From: Pete Goergen [mailto:pete.goergen@redlightmanagement.com]
Sent: Thursday, June 12, 2014 5:00 PM
To: Scala, Mary Joy
Cc: Troy Royston Royston
Subject: Fwd: 722 Preston Avenue

BRICK PIER SKETCH: 3/4" = 1'
 COCA-COLA BUILDING
 9 APRIL 2014

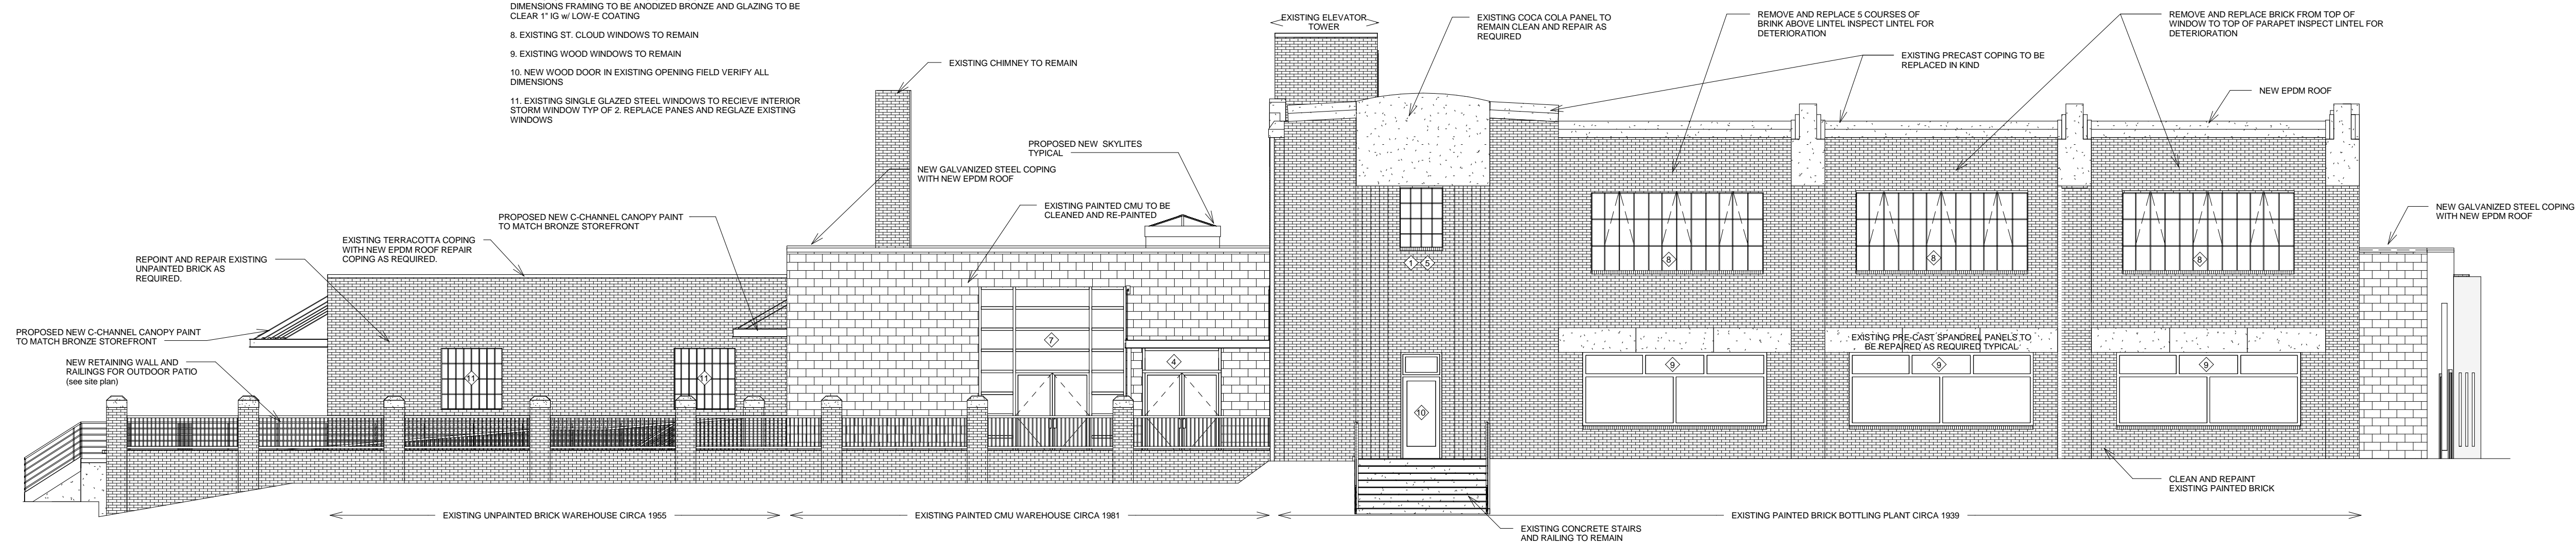
5. Have you thought about future signage? We should talk about that, in case you might need a comprehensive signage plan.

We've come up with a couple of schemes, and it'd be great to talk about them with you. When might you be available to provide some feedback?

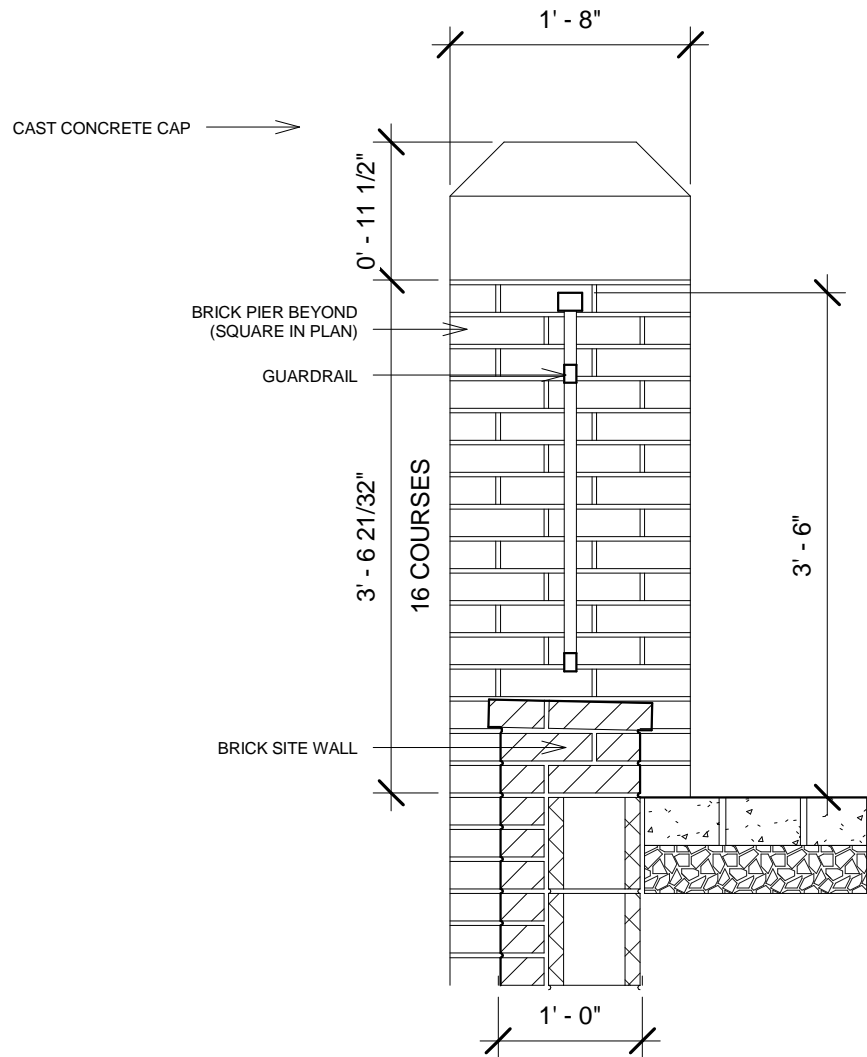
2. The BAR suggested that the caps on the patio columns replicate more closely the parapet (not the pilaster caps) on the building (more vertical dimension and softer top).

Please find attached an updated column cap that has a softer top. Let us know your thoughts whenever you have a chance to review it, and feel free to call me to discuss it.

Please find the updated caps attached.
